Access Compliance Report Public Rights-of-Way (Curb Ramps)

Main Street: HOPI_RD Cross Street: DALE_ST Location: N

ADA ID: RPAT211129131630 Ramp Type: Type 7 - Directional 2 Initial Pass/Fail: Fail Overall Compliance: No Severity Score: 16

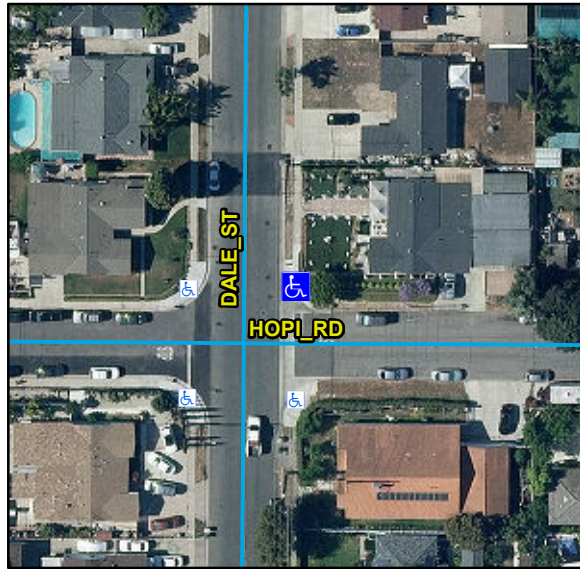
R304.2.2, R304.5.3, STD 1115

Compliance	Description	Data	Compliance	Description	Data
N/A	Ramp Length (in)	127	N/A	Flare Type LT	
Yes	Ramp Width (in)	48			N/A
No	Ramp Run Slope (%)	11.4	N/A	Flare Slope LT (%)	N/A
No	Ramp Cross Slope (%)	2.4	N/A	Flare Traversable LT	N/A
N/A	Grade Break	N/A	N/A	Flare Type RT	
N/A	Grade Break Slope (%)	N/A			N/A
N/A	Grade Break Cross Slope (%)	N/A	N/A	Flare Slope RT (%)	N/A
	Addl Para Ramp Left?	N/A	N/A	Flare Traversable RT	N/A
	Addl Para Ramp Right?	N/A	N/A	DWS Provided	N/A
N/A	Landing Present	N/A	N/A	DWS Contrast	N/A
N/A	Landing Length (in)	N/A	N/A	DWS Length (in)	N/A
N/A	Landing Width (in)	N/A	N/A	DWS Full Width	N/A
N/A	Landing Run Slope (%)	N/A		DWS Offset Type	N/A
N/A	Landing Cross Slope (%)	N/A	N/A	DWS Left Offset (in)	N/A
N/A	Landing Movement Obstructed?	N/A	N/A	DWS Right Offset (in)	N/A
	Landing Movement Type	N/A			
N/A	Landing Shared	N/A			
N/A	Marked Crosswalk 1	No	N/A	Clear Space	N/A
	Crossing 1 Direction	S	N/A	Clear Space To Crosswalk (in)	N/A

Remove & Replace Entire Ramp.
